February 2021
SF608A-D

Subject: Cascadia Road Train Brake System - Export Only

Models Affected: Specific Model Year 2020-2021 Freightliner Cascadia model vehicles, manufactured July 10, 2019, through September 14, 2020.

Specific Freightliner Cascadia right-hand-drive vehicles require a brake system modification in order to improve brake air release time, allowing for road train capability.

Fig. 1, Air Brake Plumbing Diagram

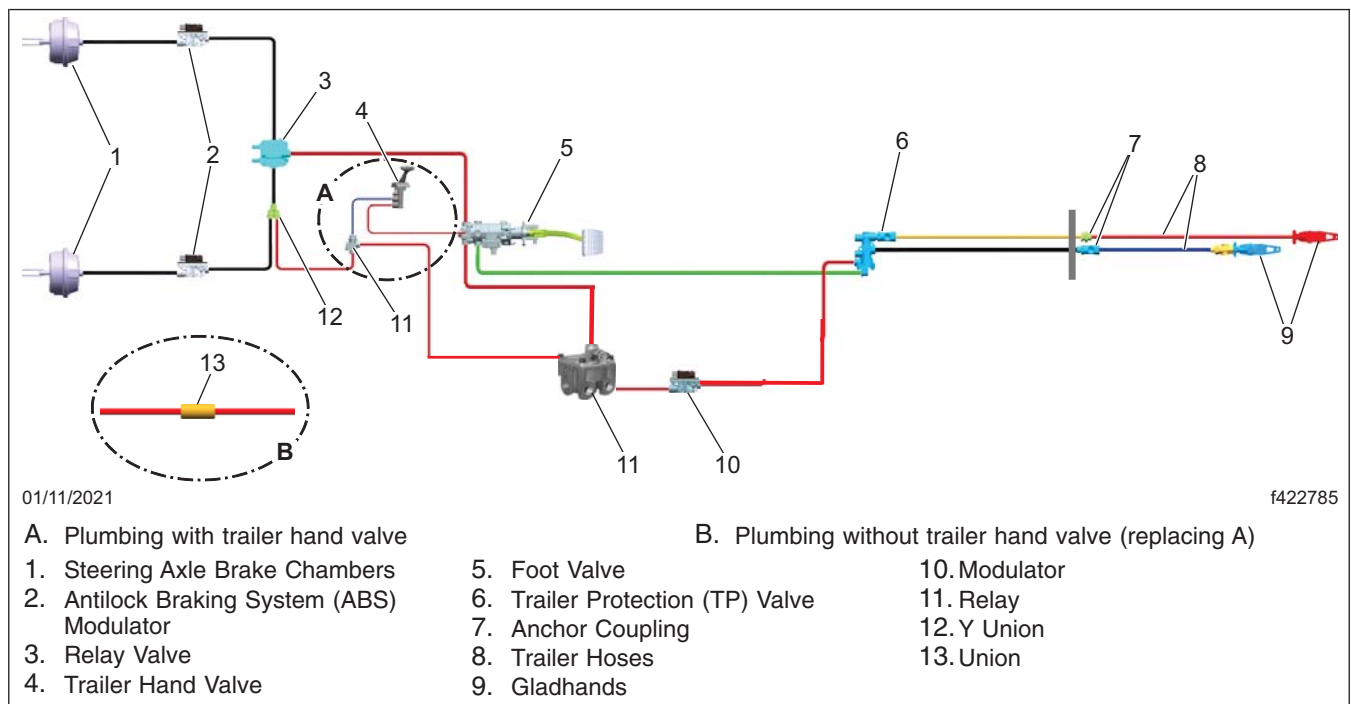
Refer to [Fig. 1](#) for air brake plumbing diagram.

Fig. 4, Air Conditioning Line Cassette Mounting Nut Locations

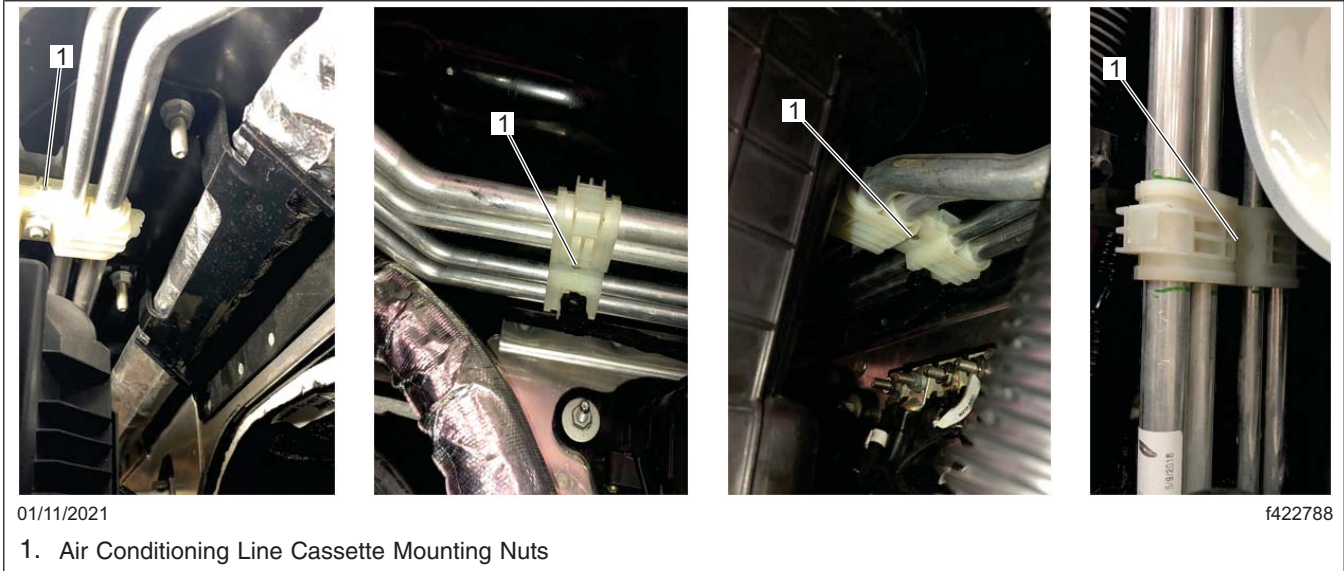
- Remove the mounting nuts that attach the air conditioning cassette lines to the underside of the engine tunnel. See [Fig 4](#) and [Fig. 5](#). This will allow the air conditioning cassette and air line mounting bracket to be lowered so the airline bundle can be removed.

Fig. 7, Disconnecting and Removing the #8 Red Air Hose

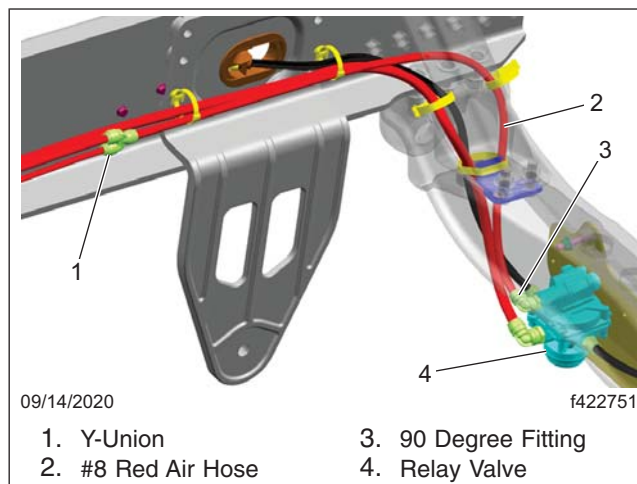
9. From the air line bundle, remove the two red #8 air lines that were connected to the front two ports on the foot valve by disconnecting them from the air line union near the fender.
10. Locate the front brakes, then disconnect and remove the #8 red air hose that connects the 90 degree fitting at the control port of the front brake relay valve to the Y-union, located in the frame rail. See [Fig. 7](#).

Fig. 8, Removing Fitting 23-14396-013

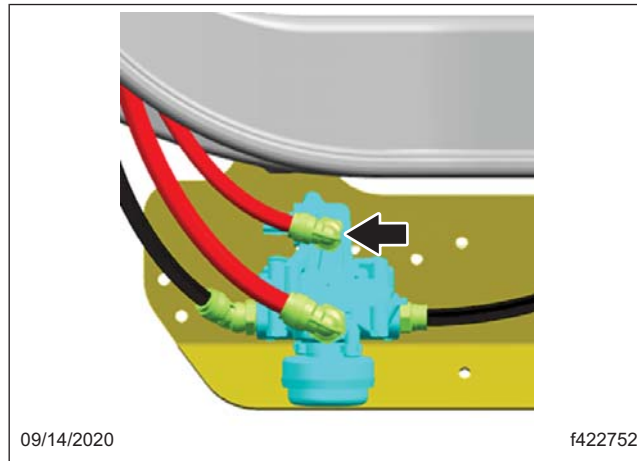
11. Remove fitting 23-14396-013 from the front brake valve control port and replace it with fitting 23-14396-006. See **Fig. 8**.

Fig. 9, Disconnecting the Red #8 Hoses

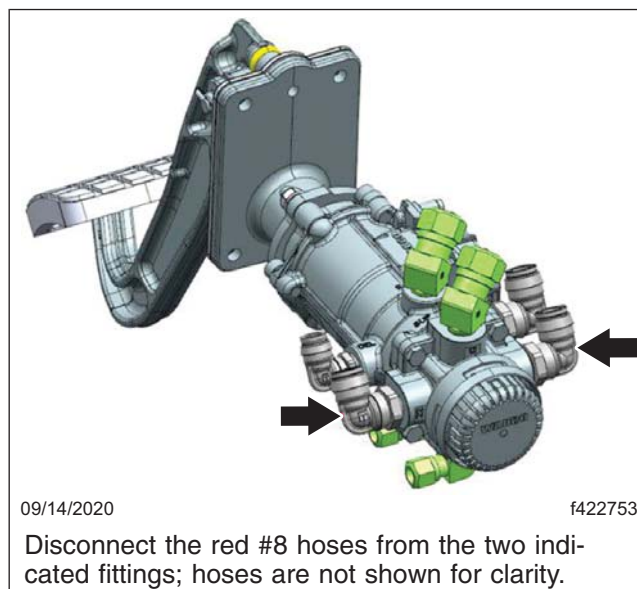
12. At the foot valve, disconnect the red #8 hoses from the two indicated fittings. Replace both 23-14396-013 fittings with 23-14396-006 fittings. See **Fig. 9**.

Fig. 10, Fitting on the Inboard Side of the Foot Valve

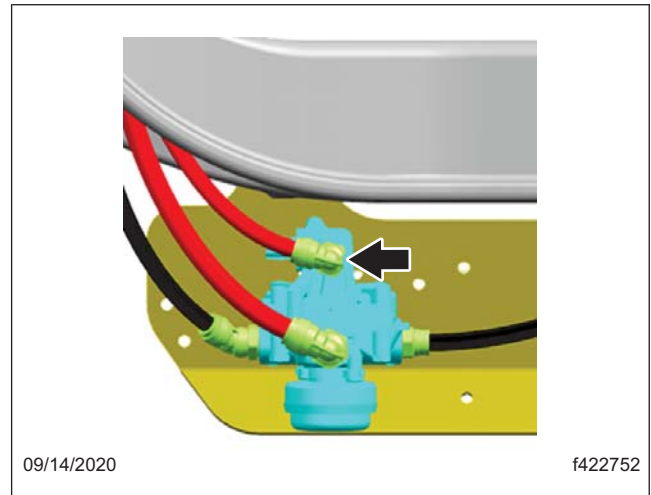
14. Add a #6 air hose (48-25811-012) from the 23-14396-006 fitting on the inboard side of the foot valve to the new fitting installed on the control port of the front brakes. See [Fig. 10](#) and [Fig. 11](#).

Fig. 12, New Y-Union Installed

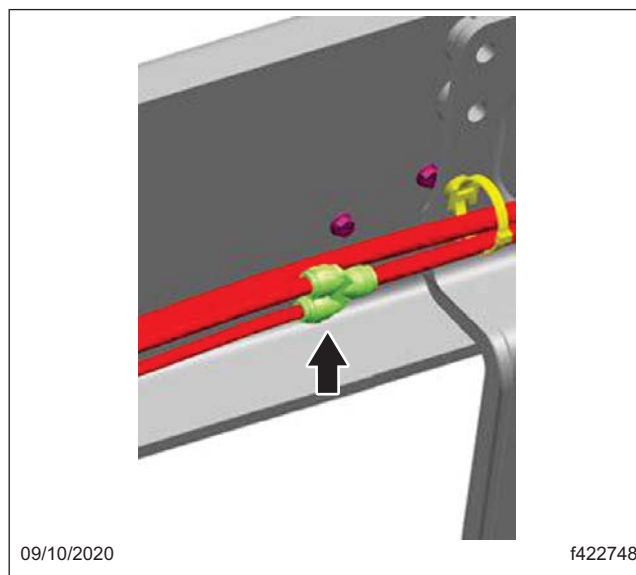
15. At the previous location of the Y-union, cut the #6 air hose and install a new Y-union (23-14401-002). Attach the #4 hose to this Y-union, in the same orientation as the previous Y-union. See [Fig. 12](#).

Fig. 13, Trailer Valve Assembly

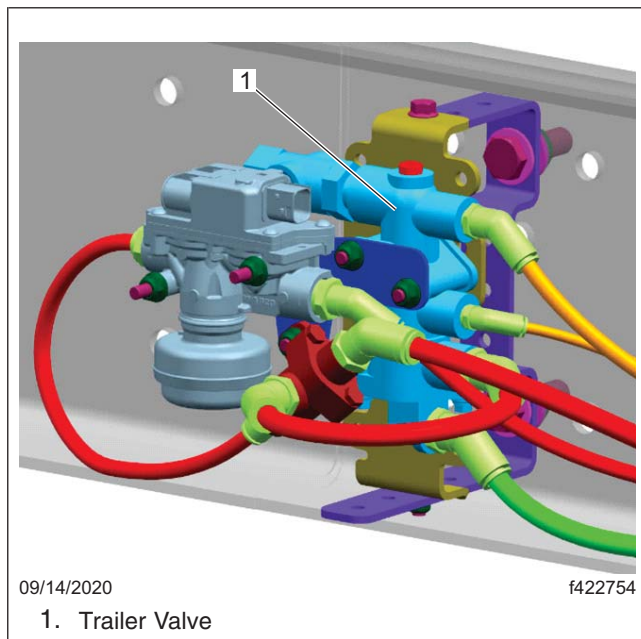
1. Disconnect all of the hoses and remove the trailer valve assembly from inside the left-hand (LH) side frame rail, under the fifth wheel. See **Fig. 13** and **Fig. 14**.

Fig. 15, R-12 Relay Valve Left Side View

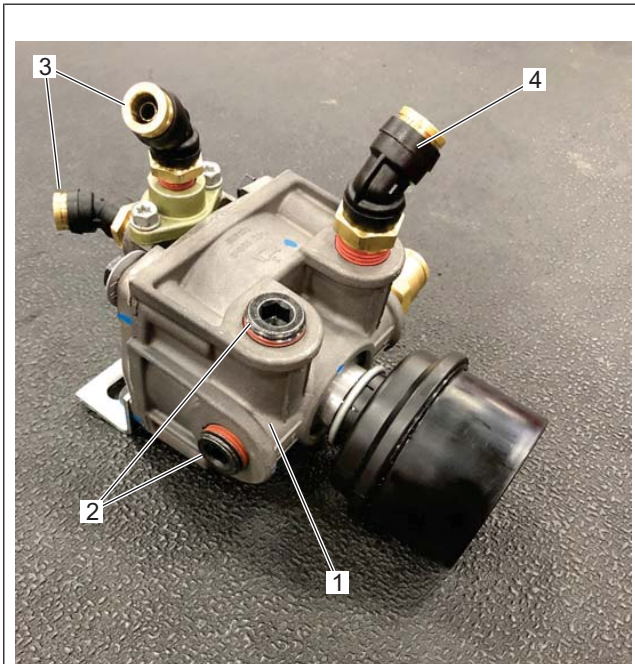
2. Remove the modulator valve from the trailer valve assembly.
3. Install plug 23-13848-001 and fittings 23-14392-014, 23-14395-003, and 23-14395-009 into the R-12 relay valve (BW K207179) as shown in [Fig. 15](#) and [Fig. 16](#) .

1. R-12 Relay Valve
2. Plug, 23-13848-001 (PLUG-PIPE,HOLLOW HEX, 1/2 MPT)
3. Elbow Joint, 23-14395-003 (ELB-45, 3/8 PTC X 1/4 MPT)
4. Elbow Joint, 23-14395-009 (ELB-45, 1/2 PTC X 1/2 MPT)

Fig. 17, R-12 Relay Valve Assembly

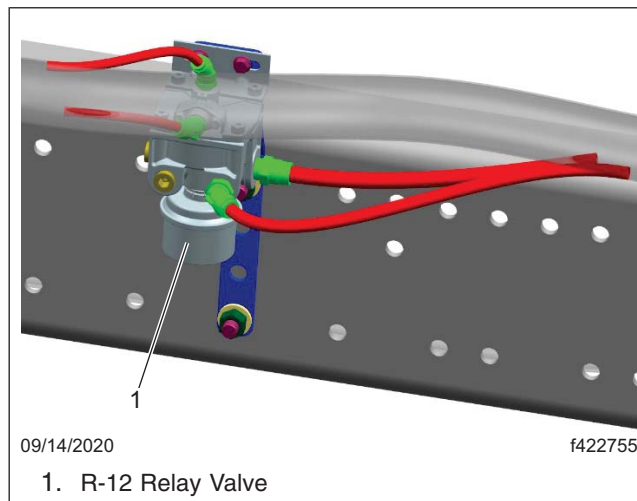
4. Assemble the R-12 relay valve assembly on the vehicle as follows. See [Fig. 17](#).

Fig. 18, Forward Fasteners

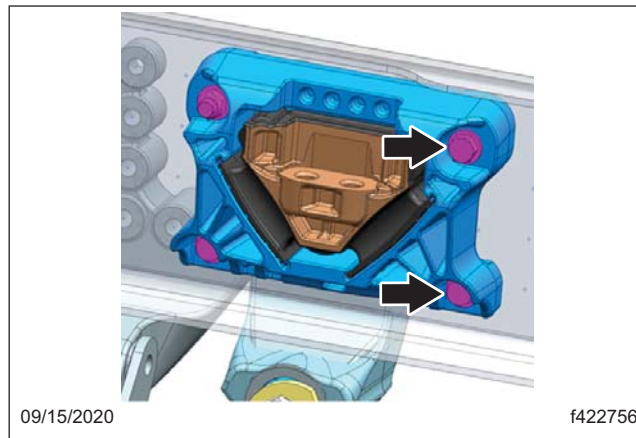
- 4.1 Remove the forward fasteners from the left-hand (LH) rear engine mount. See [Fig. 18](#).

Fig. 19, Relay Assembly Attached with the Forward Fasteners

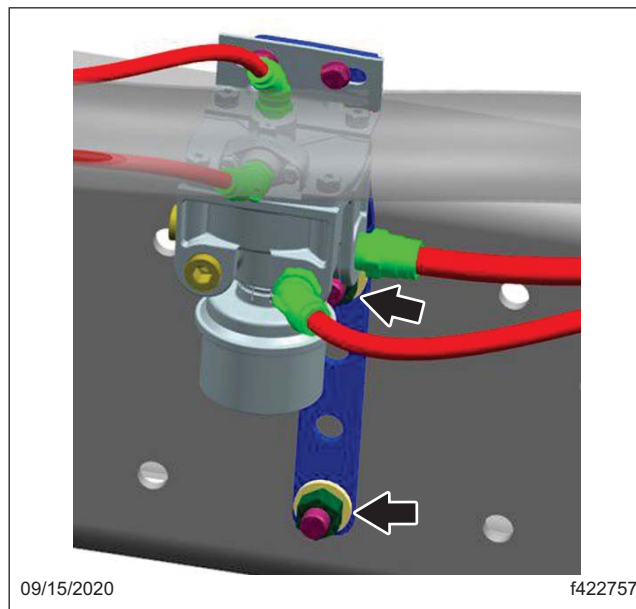
- 4.2 Install them through the relay assembly on the outside of the frame rail. See [Fig. 19](#).

Fig. 20, Trailer Valve Assembly

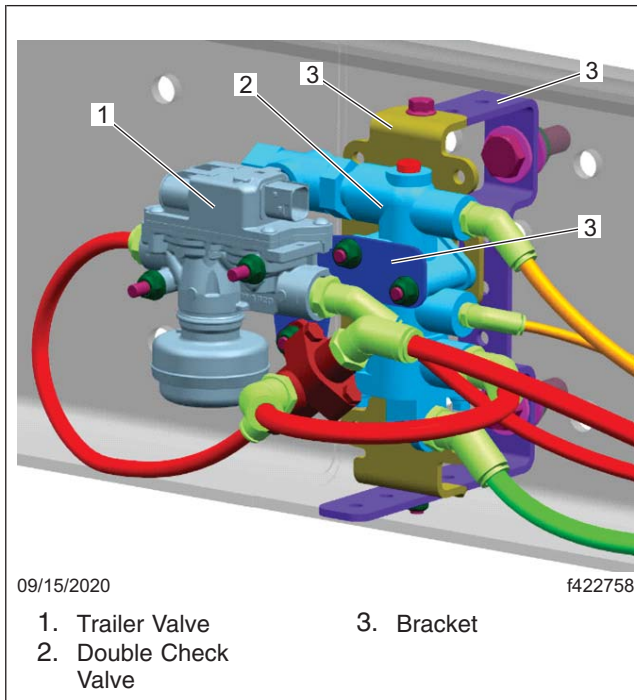
5. Remove the trailer valve assembly, including the brackets and double check valve. See [Fig. 20](#).
6. Assemble the new modulator assembly as shown in [Fig. 21](#).

Fig. 22, Modulator Assembly Installed

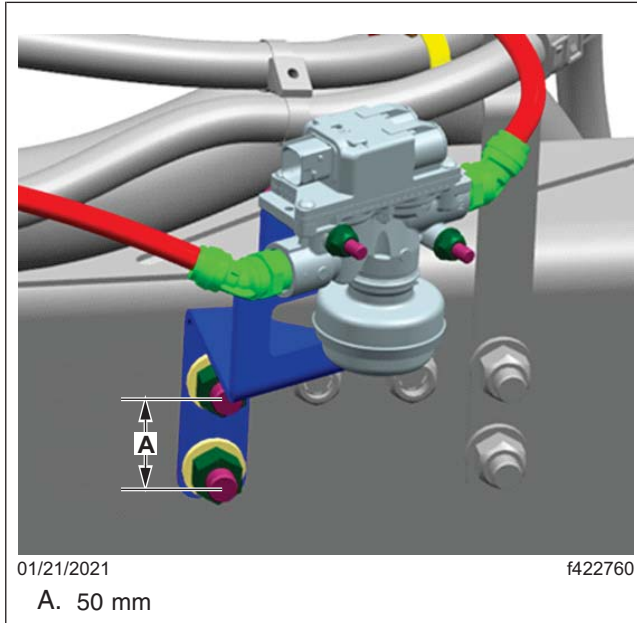
7. At frame location 1225 mm on the left frame rail, drill a hole 50 mm below the existing hole that holds the fastener for a routing and clipping bracket. Install the modulator assembly as shown in [Fig. 22](#).

Fig. 23, Additional Washer to be Installed on Vehicles with a 53-Gallon DEF Tank

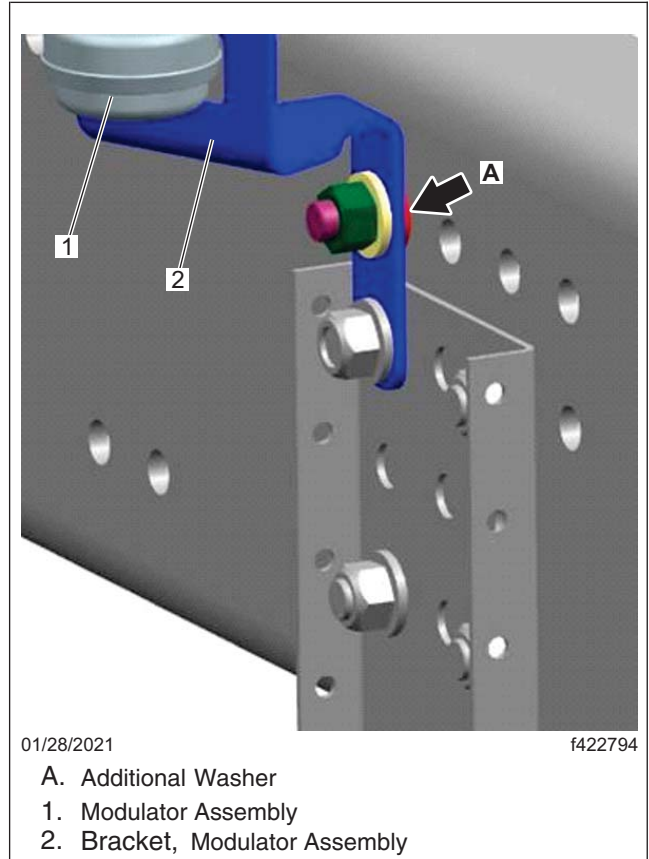
For vehicles equipped with a 53-gallon diesel exhaust fluid (DEF) tank, install a washer on the upper fastener, between the modulator bracket and the frame. See [Fig. 23](#).

Fig. 24, Tractor Protection Valve Assembly

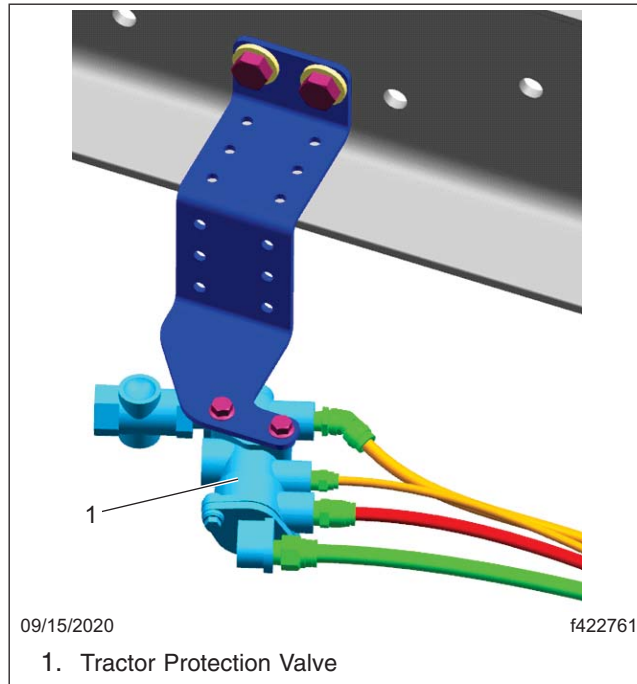
8. Assemble the new tractor protection valve assembly as shown in [Fig. 24](#).

10. Mount the new tractor protection valve assembly as shown on the two drilled holes. See [Fig. 24](#).

Fig. 25, Drill Pattern

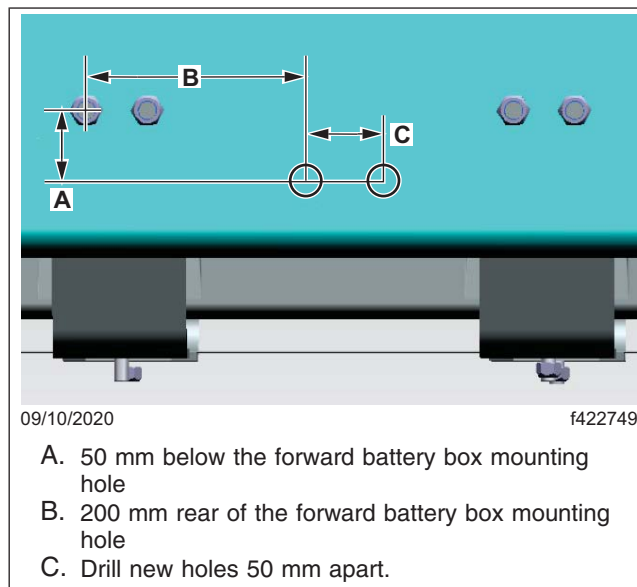
9. Drill a pattern of two 50 mm holes that are 200 mm rear and 50 mm below the forward battery box mounting hole on the left frame rail as shown in [Fig. 25](#).

Fig. 26, Foot Valve, Air Fitting

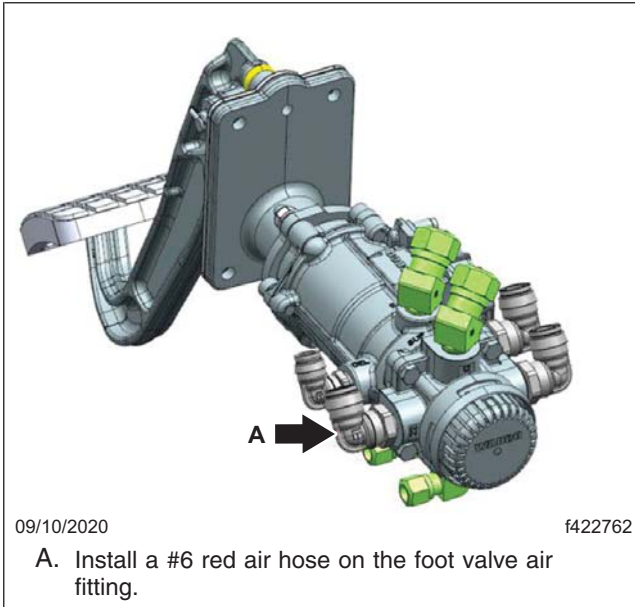
11. Install a #6 red air hose on the foot valve air fitting, shown in [Fig. 26](#), to the top control port on the R-12 relay. See [Fig. 27](#).

Fig. 28, Shortening the #6 Red Air Hose

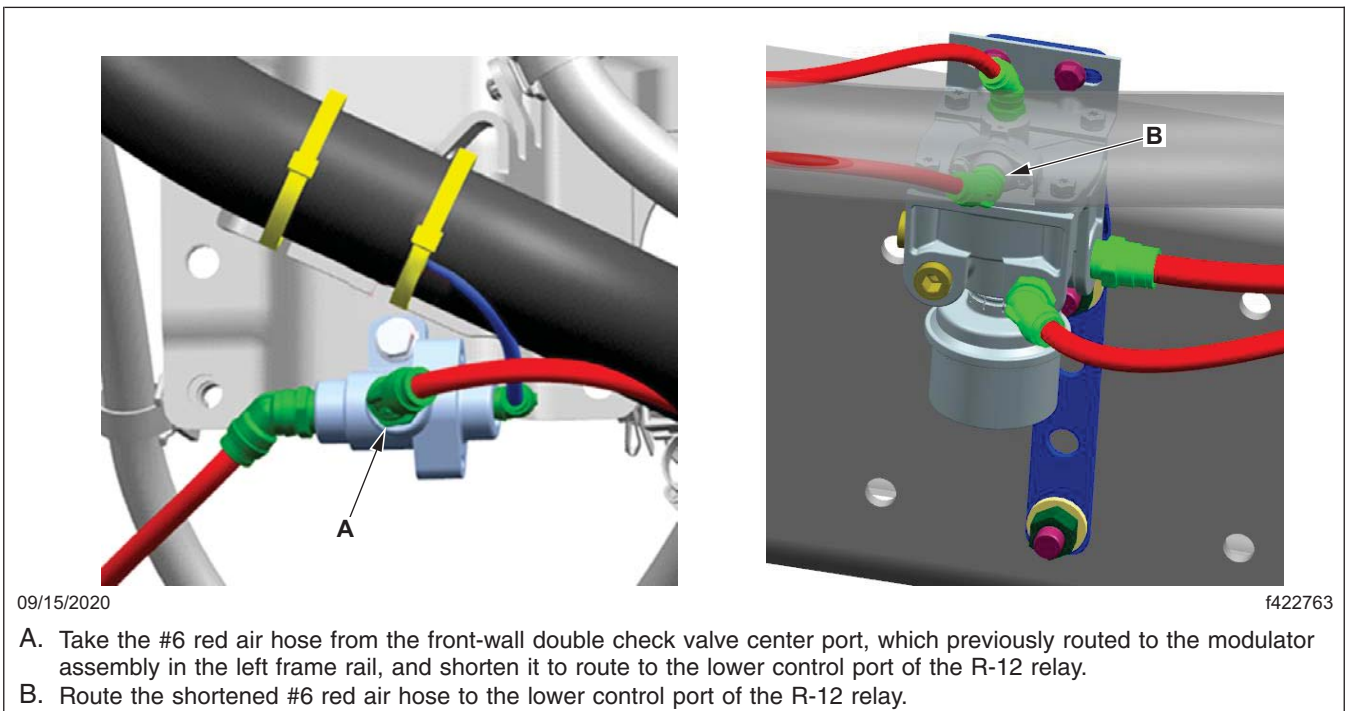
12. Take the #6 red air hose from the front-wall double check valve center port, which previously routed to the modulator assembly in the left frame rail, and shorten it to route to the lower control port of the R-12 relay. See [Fig. 28](#).

Fig. 29, Secondary Air Tank

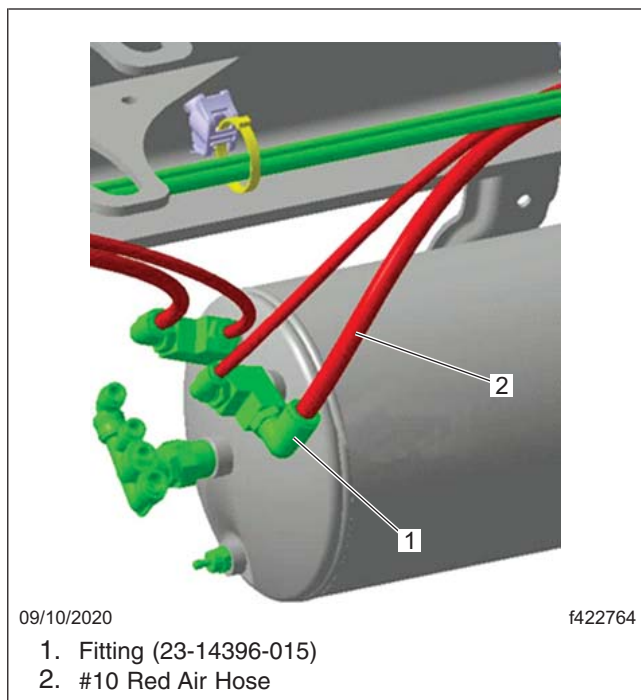
13. Add one air fitting (23-14396-015) to an available port on the secondary air tank. See [Fig. 29](#). An additional brass T-fitting may be required if there is no port available. Route a #10 red air hose from this air fitting to the supply port on the R-12 relay. See [Fig. 30](#).

Fig. 31, R-12 Relay, Delivery Port

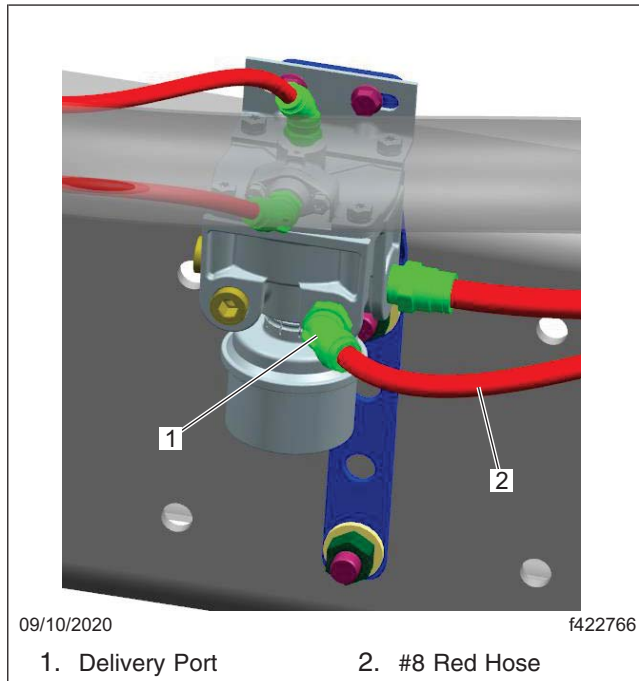
14. Connect a #8 red hose to the delivery port of the R-12 relay and to the supply port of the modulator valve.
See [Fig. 31](#) and [Fig. 32](#).

Fig. 33, Removing the Red #8 Hose from the Fitting, Tractor Protection Valve

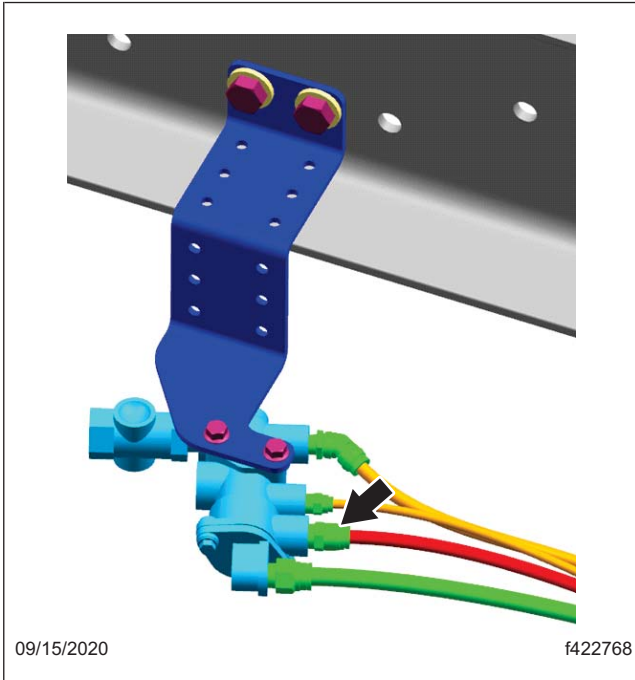
15. On the tractor protection valve, remove the red #8 hose from the fitting shown in [Fig. 33](#). Install a #8 red hose on the modulator valve delivery port to the indicated fitting on the tractor protection valve. See [Fig. 34](#).
